GRACE VALLEY RANCH, PHASE 6

ADDENDUM #2

05/16/2025

C6.07

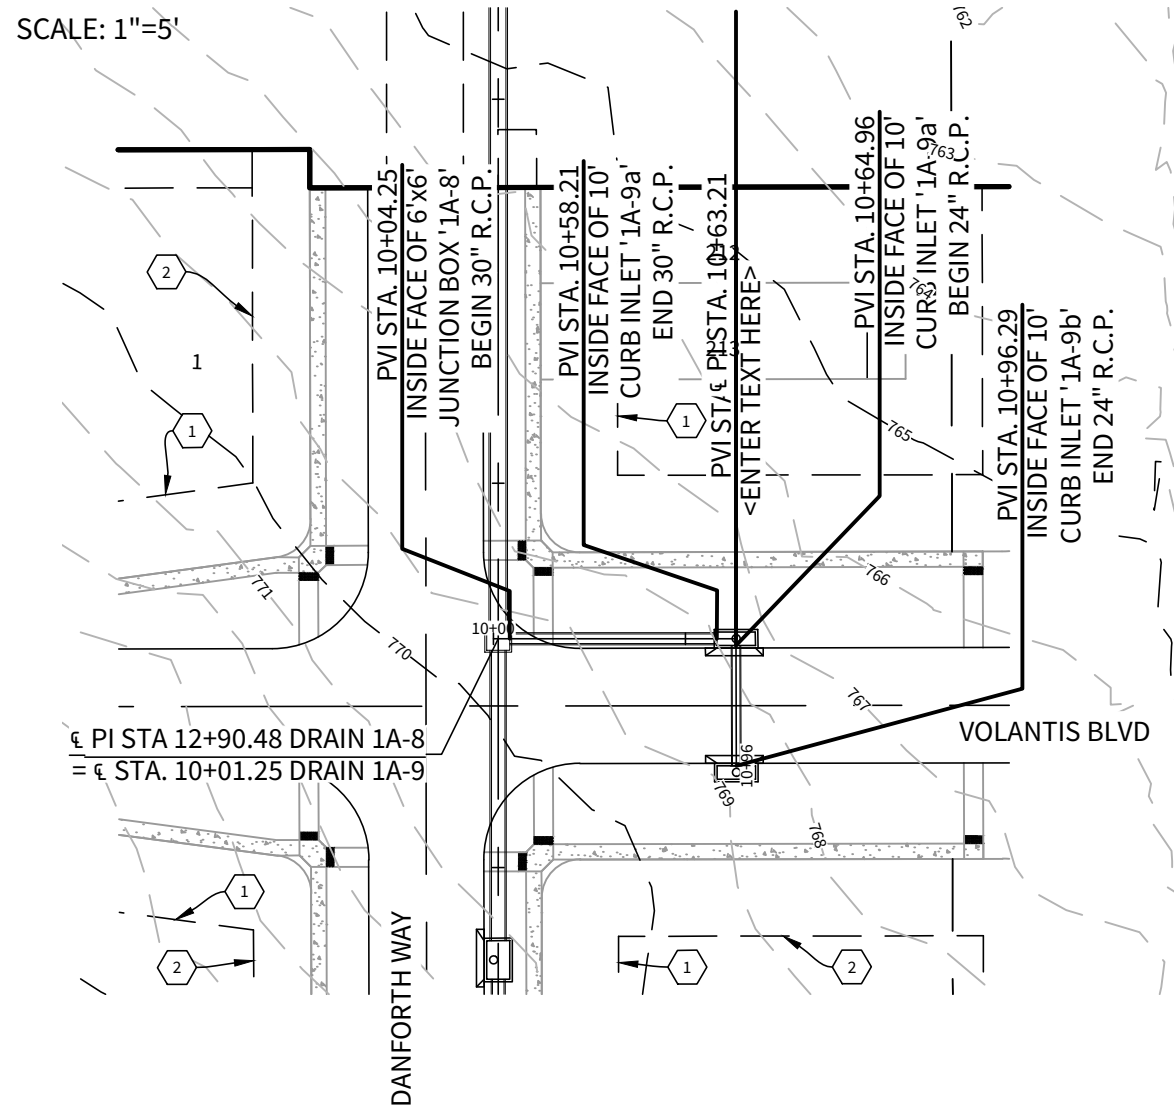
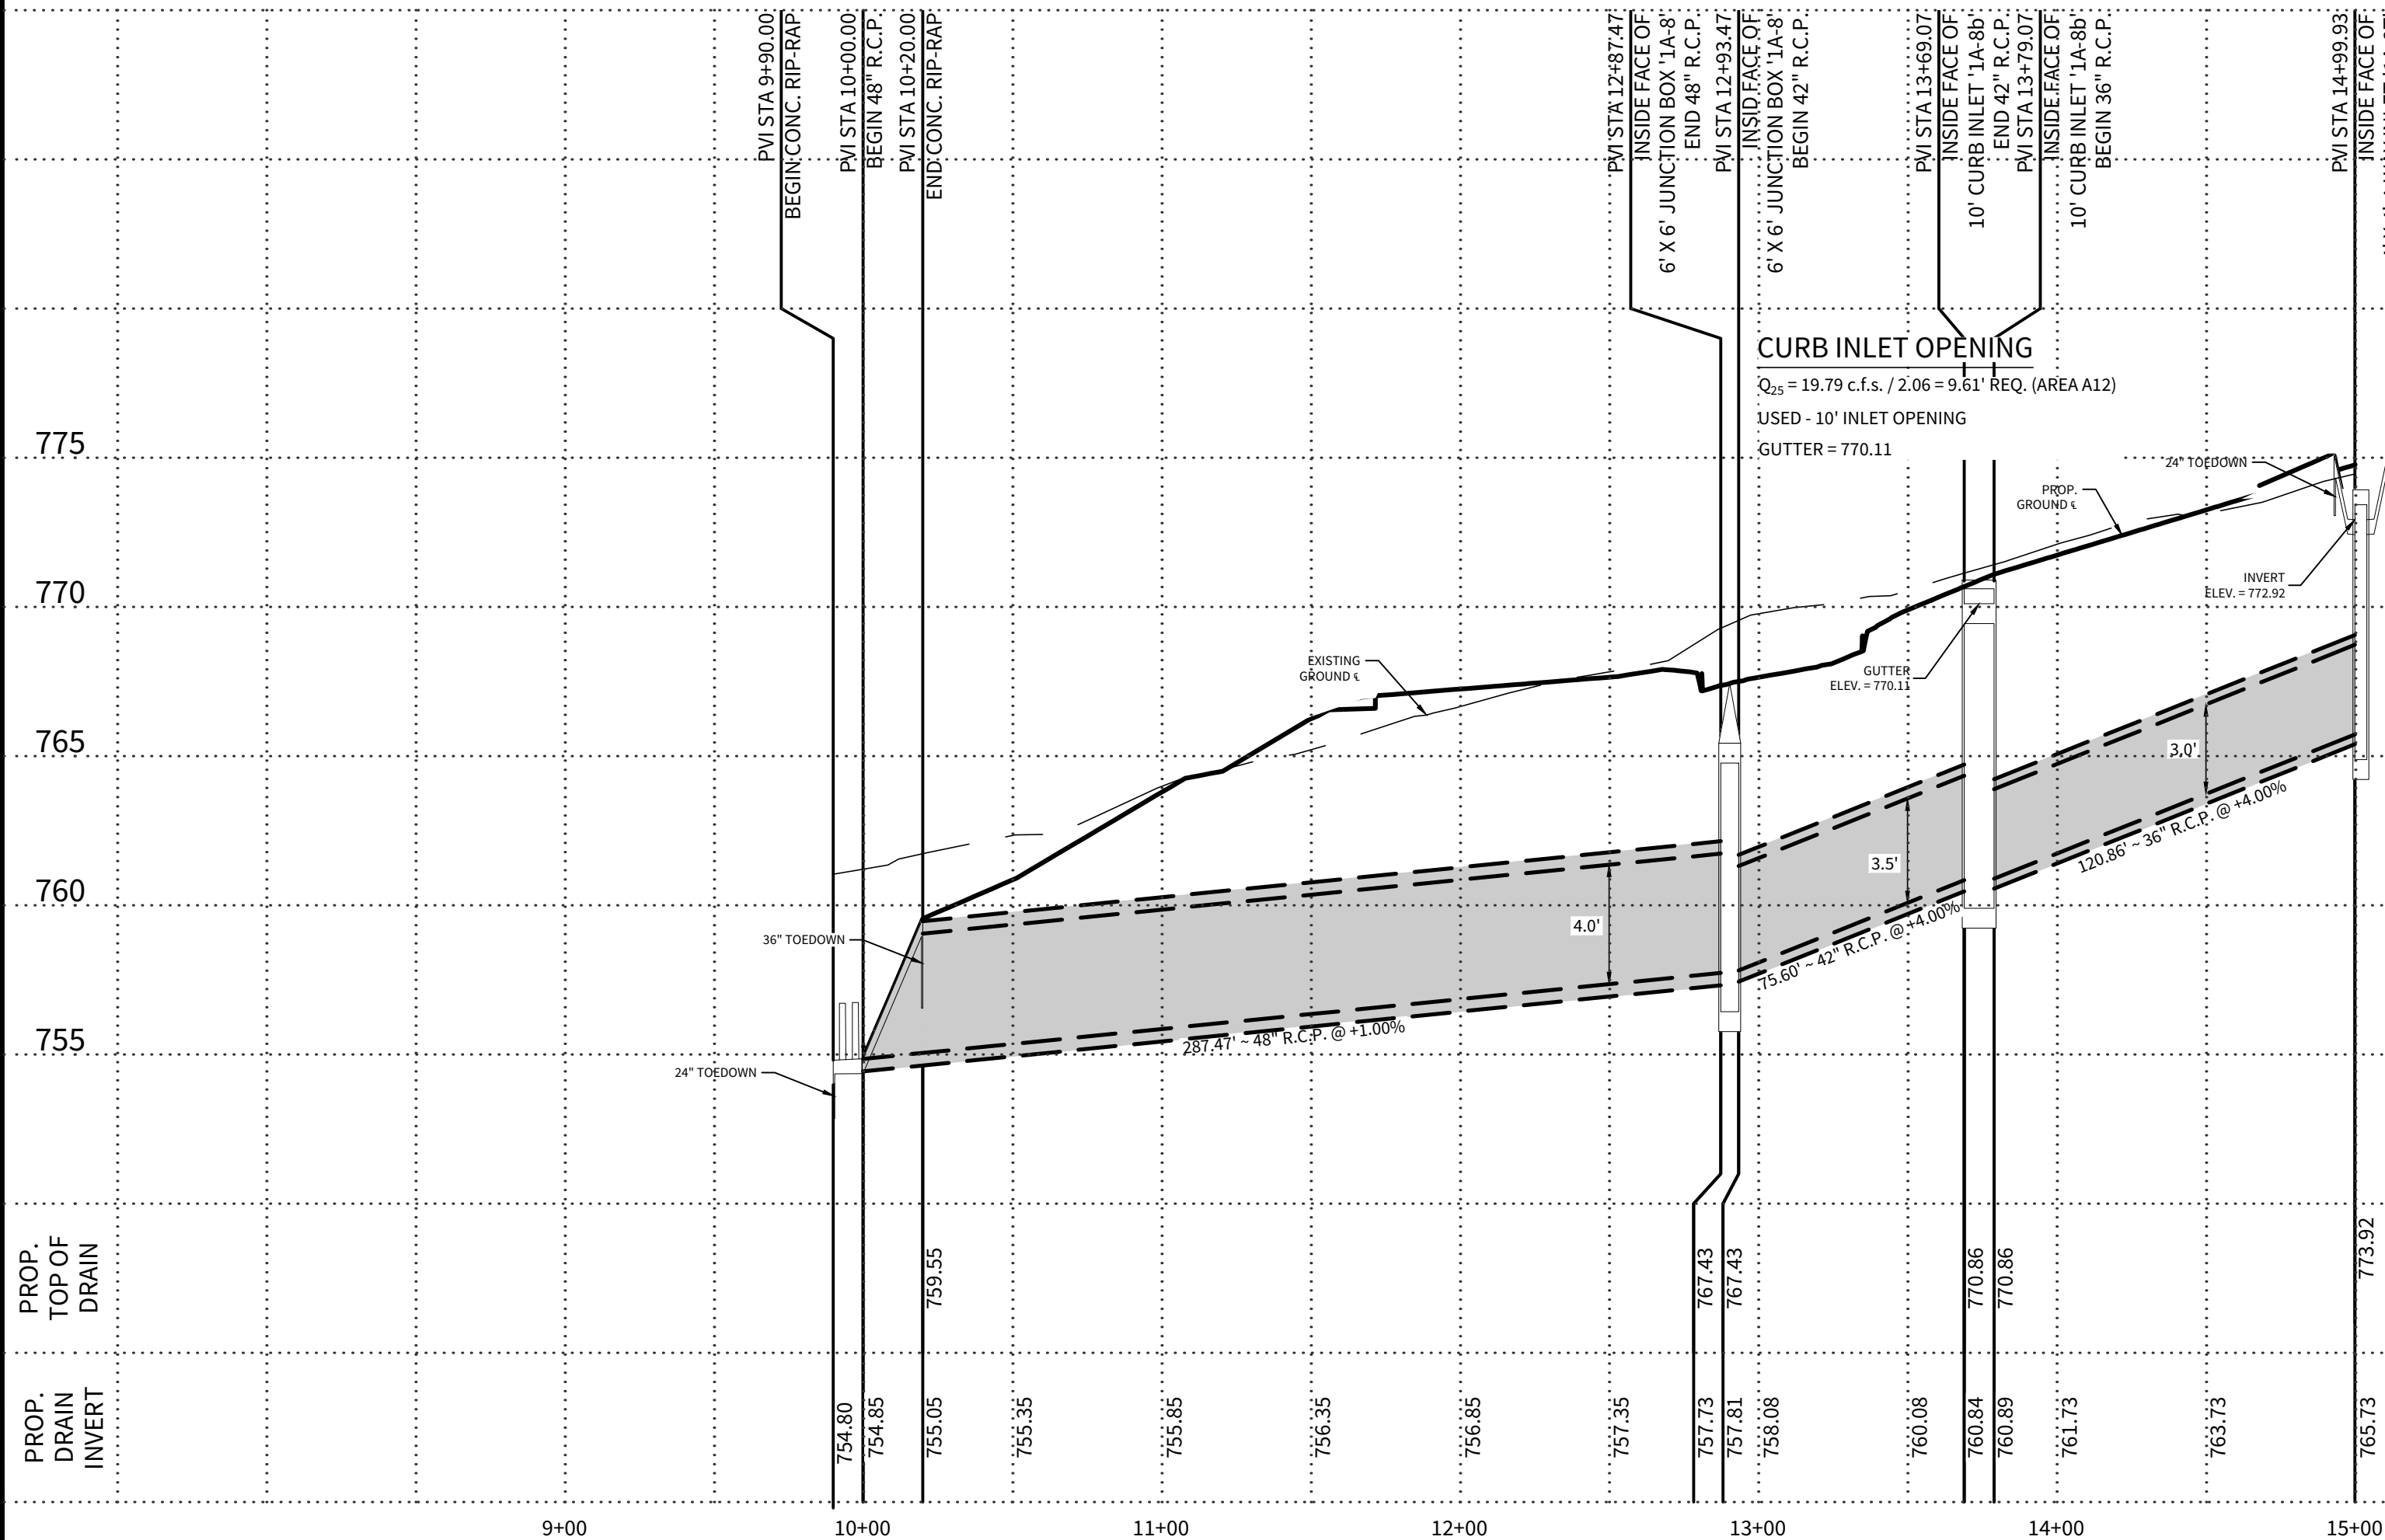
- Question 27** Bid tab calls for (2) 4x4 4-way inlet. Plans show (1).
Answer 27 *Sheet C6.07 has been revised with Addendum #2 showing the second 4-way inlet. Bid form has been adjusted to reflect this inlet.*

E1

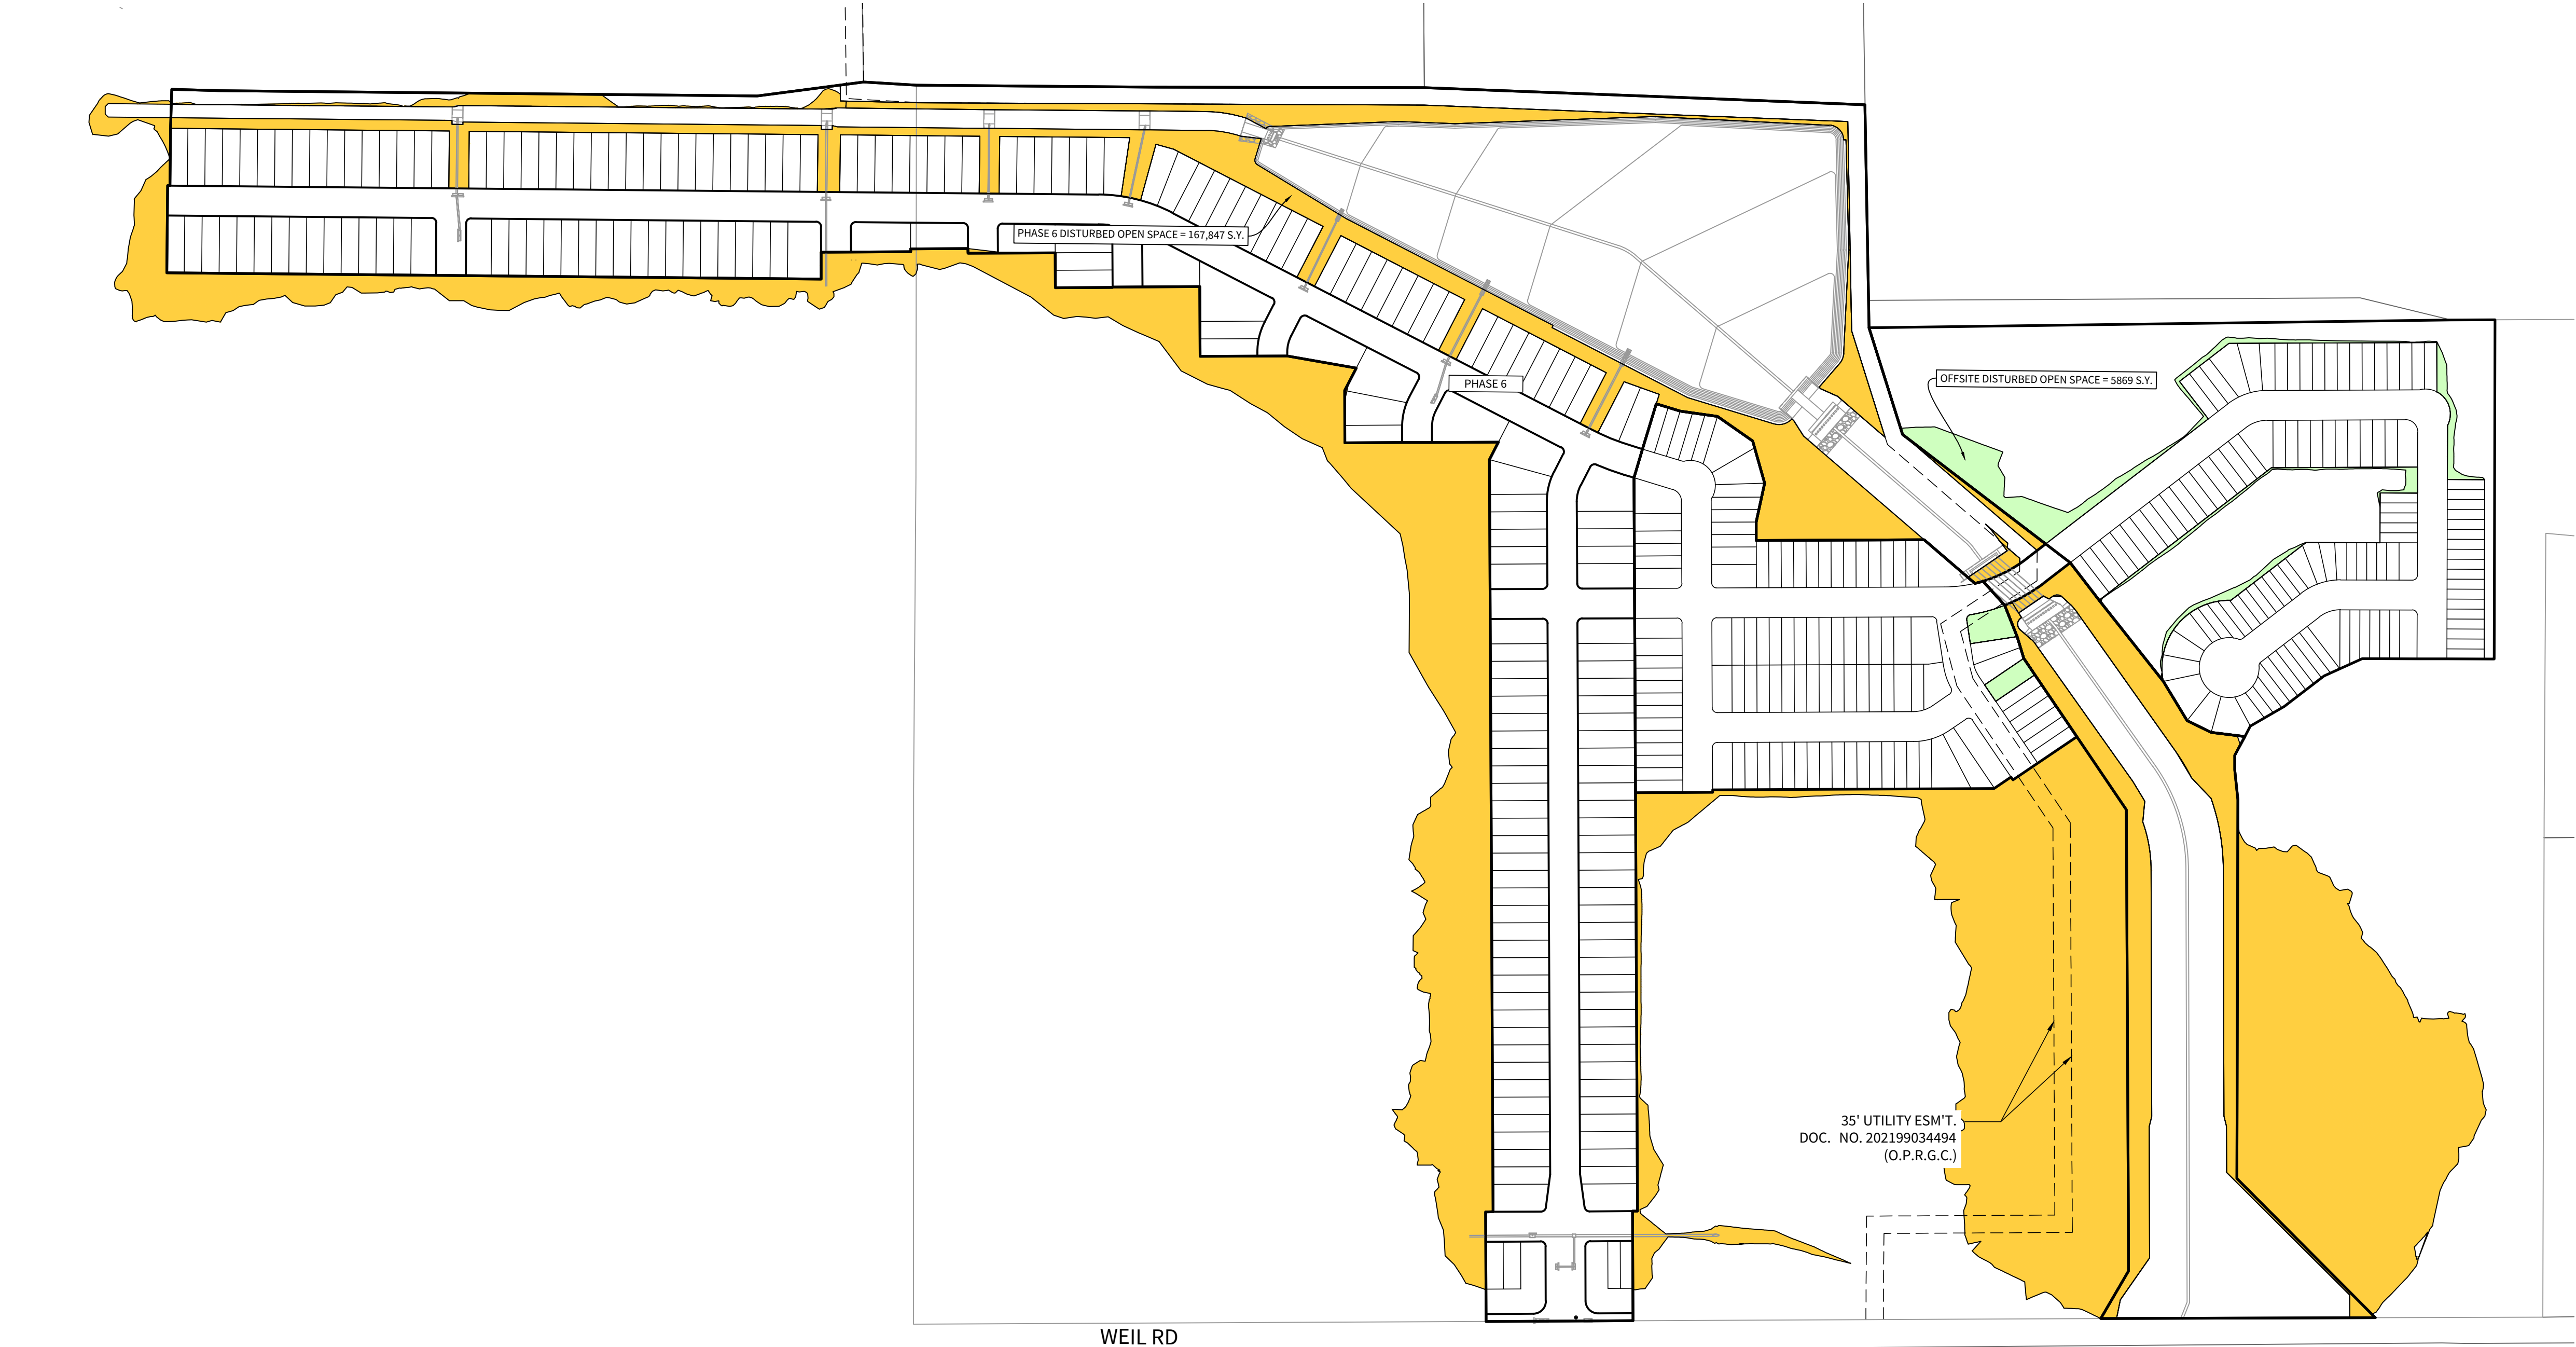
Answer 20 *Bid form has been revised to 1,554 LF of Rock Berm with Addendum #2.*
- Question 21** Can we get an exhibit showing the Disturbed Open Space areas that are included in the 83,983 SY of Hydromulching?

Answer 21 *An exhibit is included with the limits of Hyrdromulch. Quantities have been updates accordingly in the Bid Form included with Addendum #2.*
- Question 22** Bid tab calls for 276 SY of Sidewalk. Plan show 127 SY.
